**CONDITIONALLY APPROVING FINAL SUBDIVISION PLAT OF
GRANDVIEW MEADOWS**

RE: Preliminary Plat, Bloomfield Acres/Grandview Meadows
13-16-1.14

PRELIMINARY PLAT GRANDVIEW MEADOWS

JOB NUMBER
CC 1783
SHEET
4 OF 4

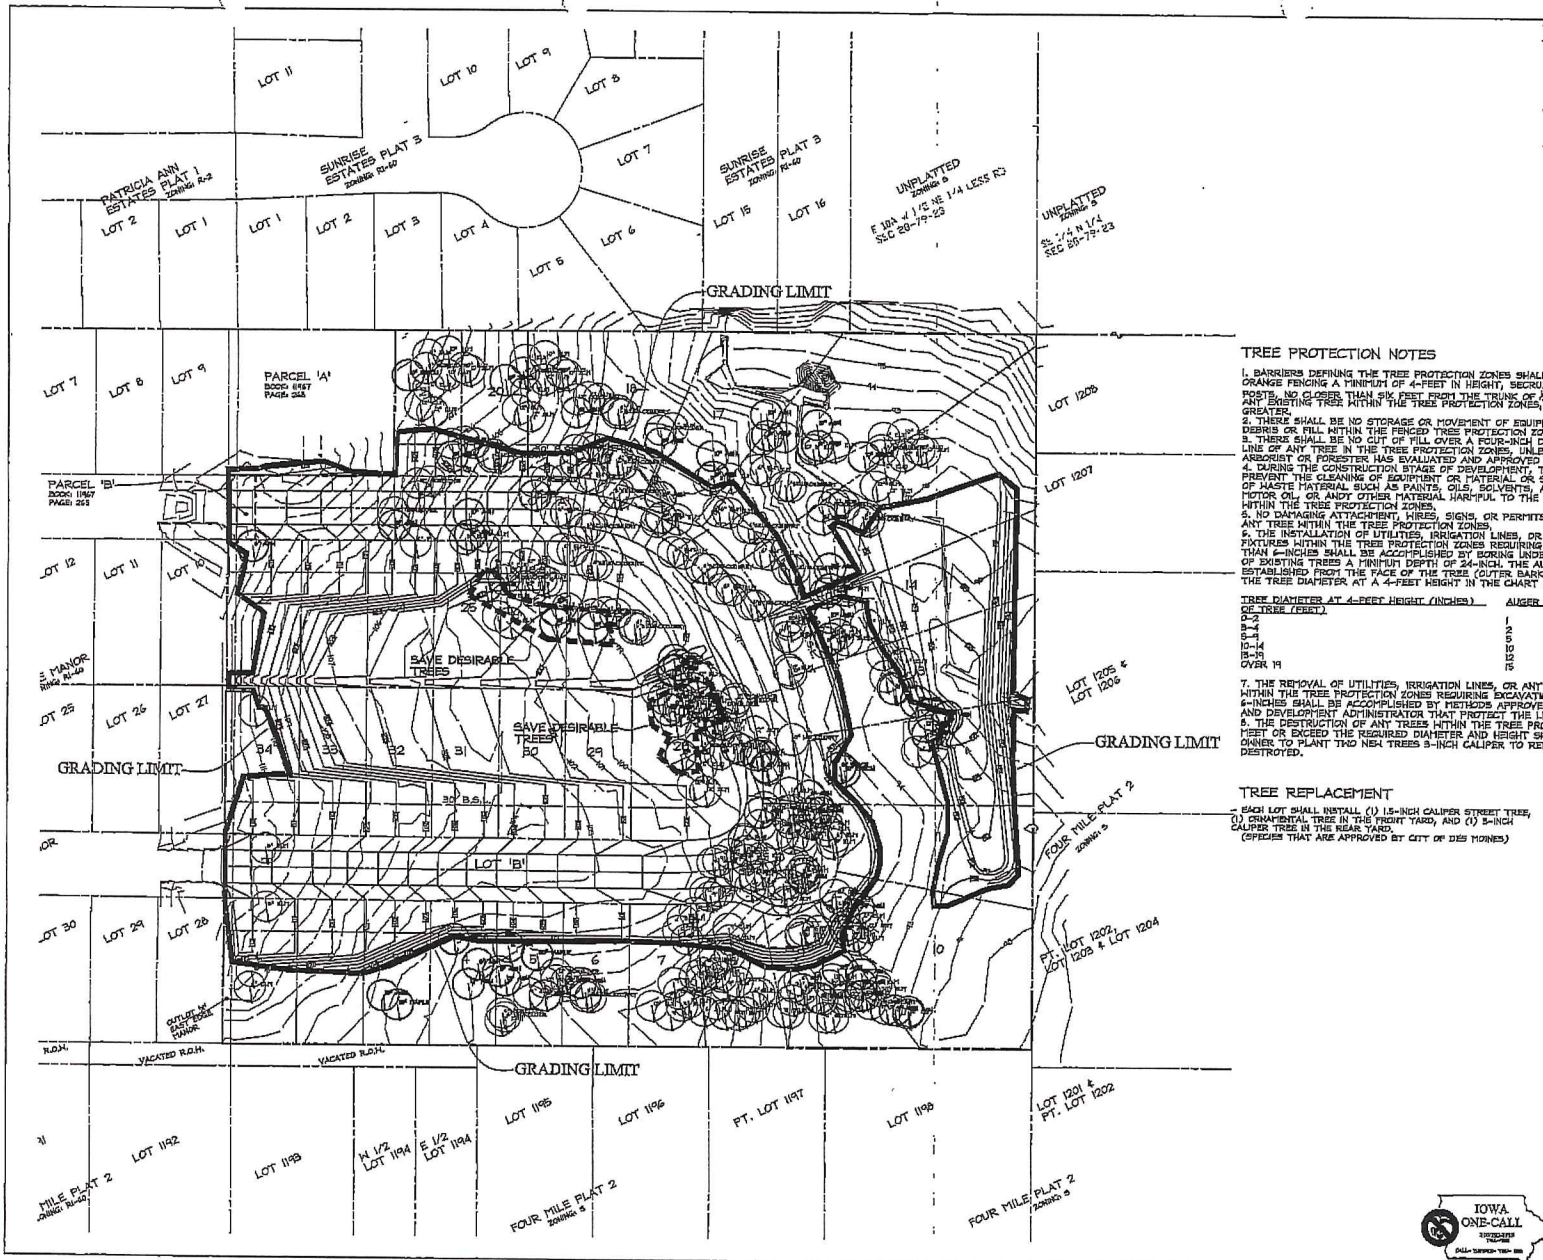
3. Provide a detail of the proposed outlet structure(s) on the plat. The detail should specify the elevation and sizes of the pipes/ orifices.
4. The temporary sediment basin detail on the plat shows a 15" outlet pipe. The Stormwater Report notes that this as a 12" pipe. The plan view on the plat shows this as a 10" pipe. Please define a size for this outlet pipe.

UTILITY PLAN
GRANDVIEW MEADOWS

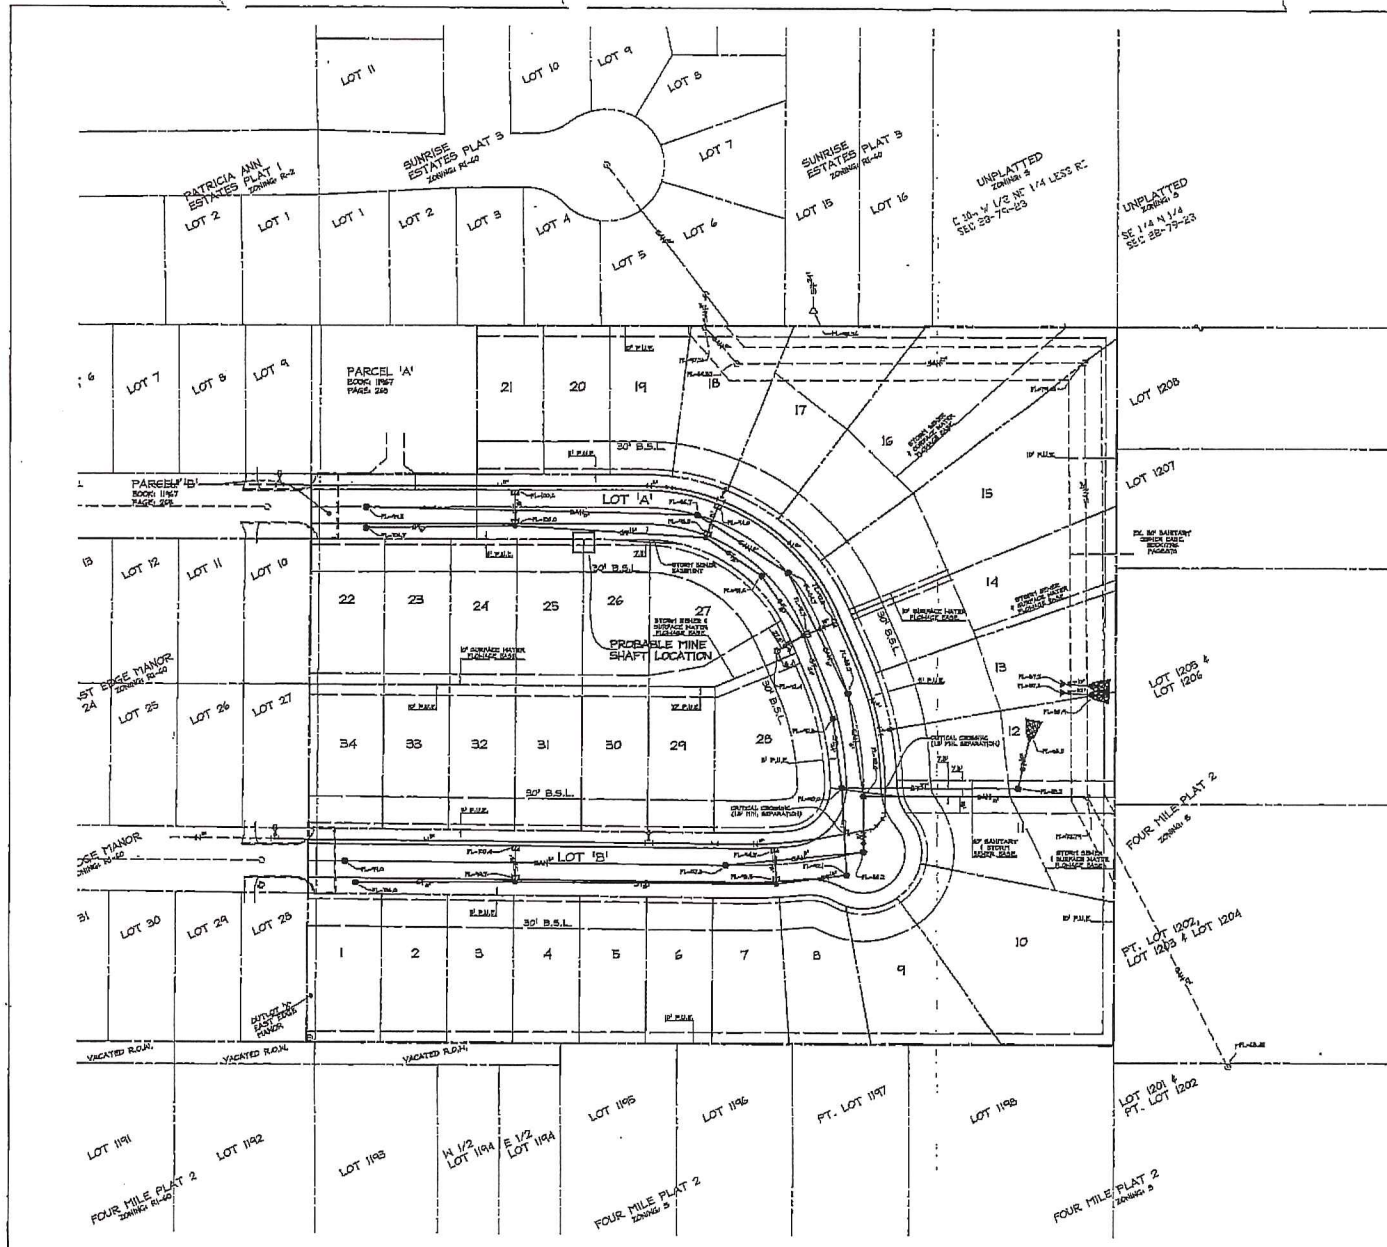
** PAVEMENT SUBDRAIN DESIGN FOR THIS PLAT SHALL BE INCLUDED IN THE DETAILED CONSTRUCTION DRAWINGS AND SUBMITTED TO THE CITY OF DES MOINES FOR REVIEW AND APPROVAL. SUBDRAIN DESIGN FOLLOW THE RECOMMENDATIONS OF THE GEOTECHNICAL REPORT.**
